TO: Urban Design Commission
FROM: David C. Dryer, City Traffic Engineer & Parking Manager
SUBJECT: 333 West Washington Avenue project

Re: Letter of Intent, Capitol West (Phase II), PUD – SIP

Project: Capitol West – Phase II, Hyatt Place Hotel
333. W. Washington Ave.

**Re: Urban Design Commission Submittal – Initial/Final approval requested
Capitol West (Phase II), PUD – SIP
UDC GDP comments addressed**

DRAWING TITLE
**Overall Site Development And
 Site Circulation Plans**

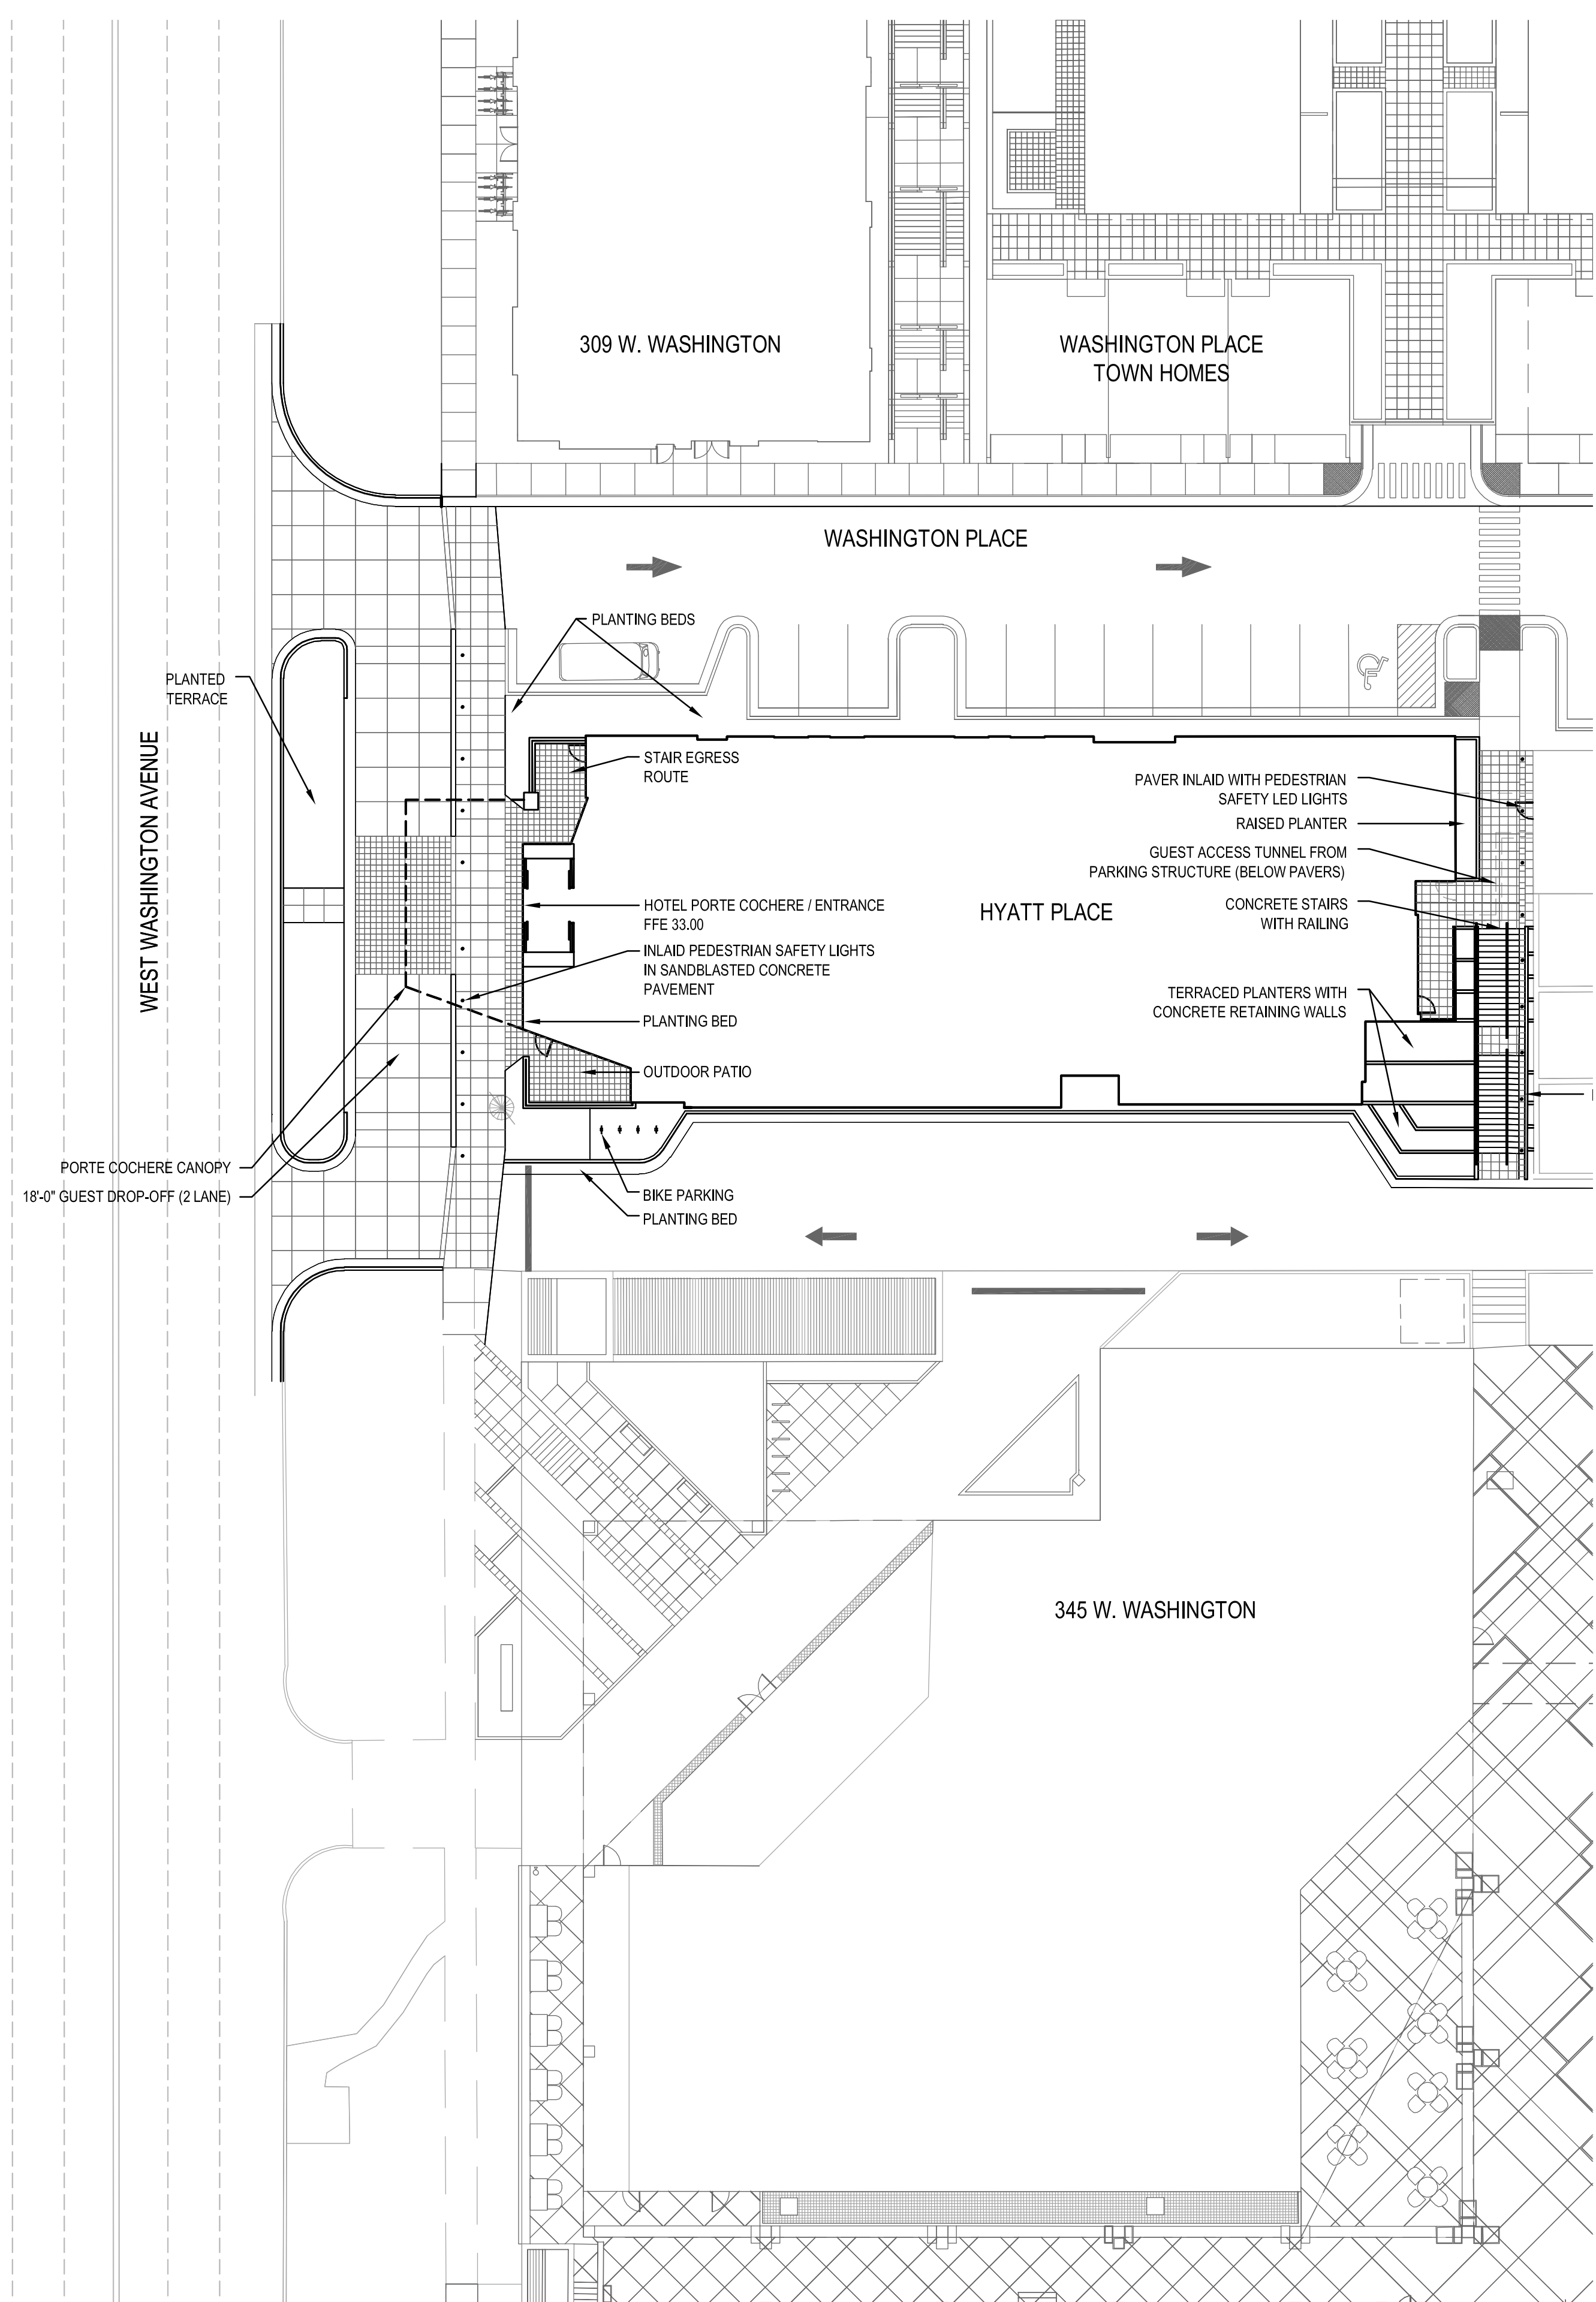
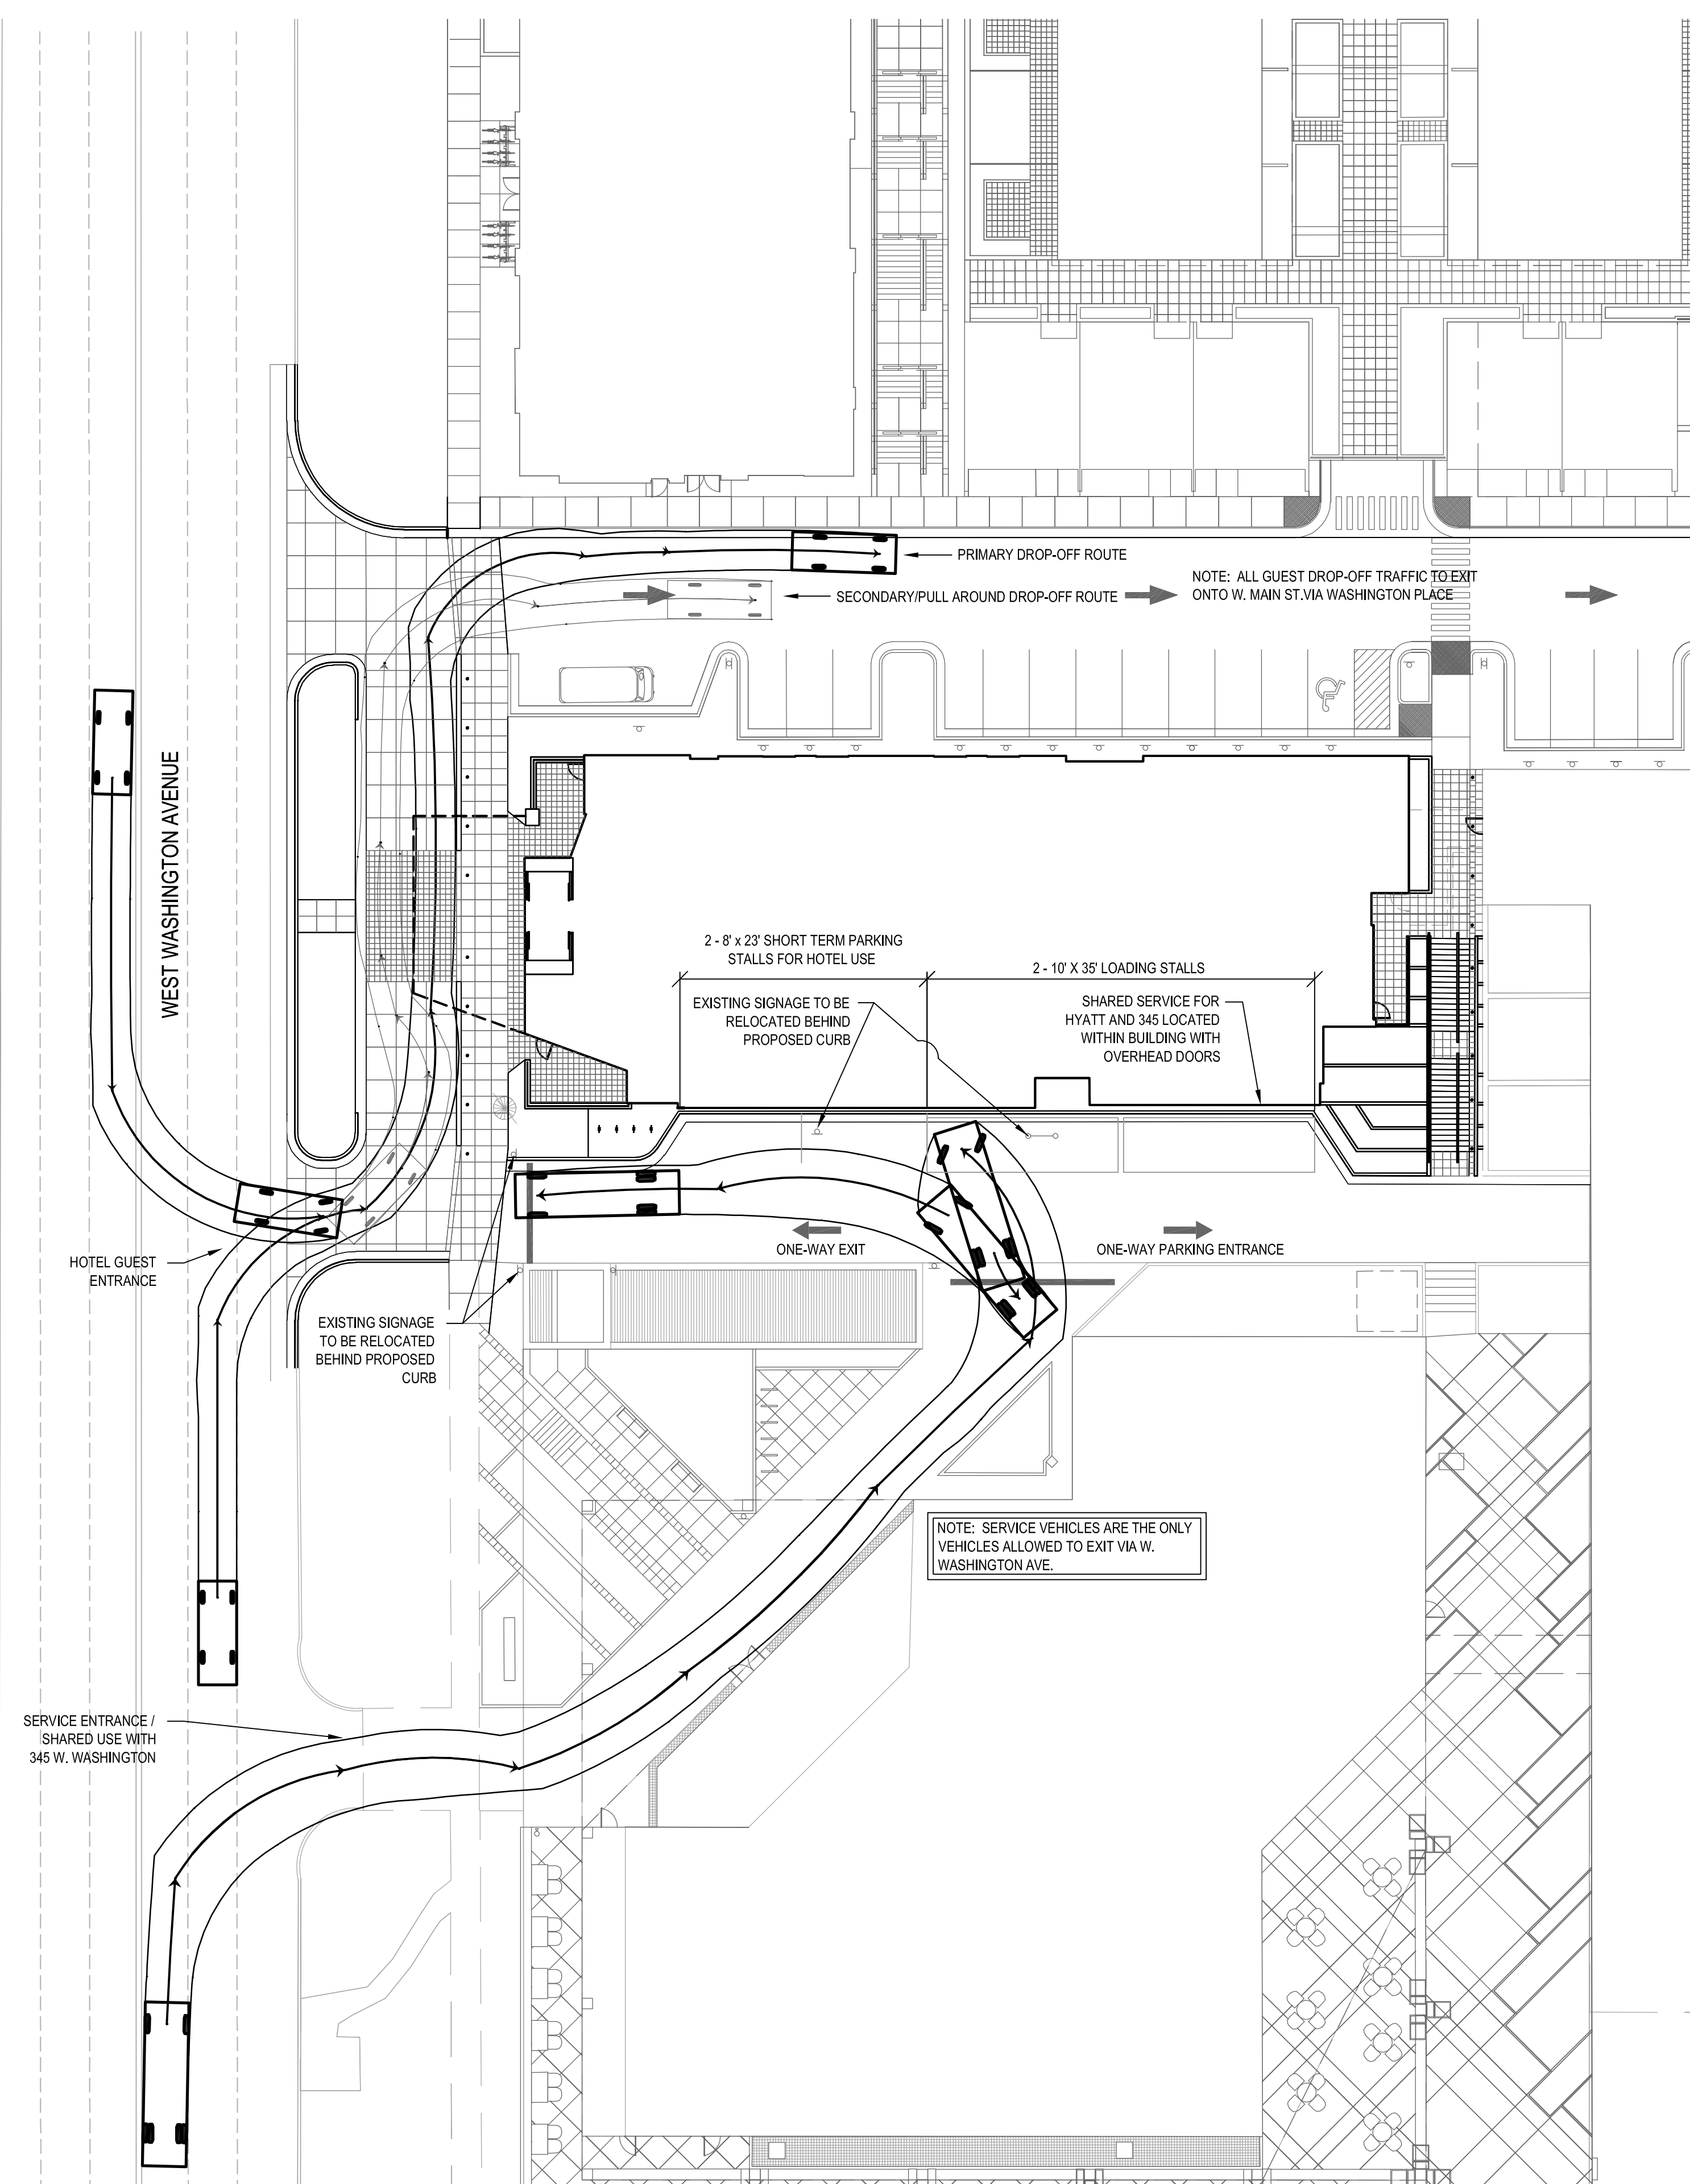
- C Object to vehicular movement limitations and one-way on Washington Place.
- C Slow traffic around drop-off doesn't really work with adjacent property issues, an unsafe situation creates a traffic bottleneck.

- C Relook at traffic circulation to make more functional.
 - R Discussions are ongoing with The Alexander Company, City of Madison Traffic Engineering and the Hyatt team to create a more efficient solution. Alexander Company and the design team prefer two-way traffic on Washington Place.

- R The off street drop-off is purposely proposed to minimize bottleneck situations by removing slower stop-n-go traffic from W. Washington Ave. Curbside drop-off creates more congestion and conflict potential. On-site options proved to be too inefficient and complicated due to site massing and grading as presented and discussed at previous (GDP – UDC, PC, CC) presentations.
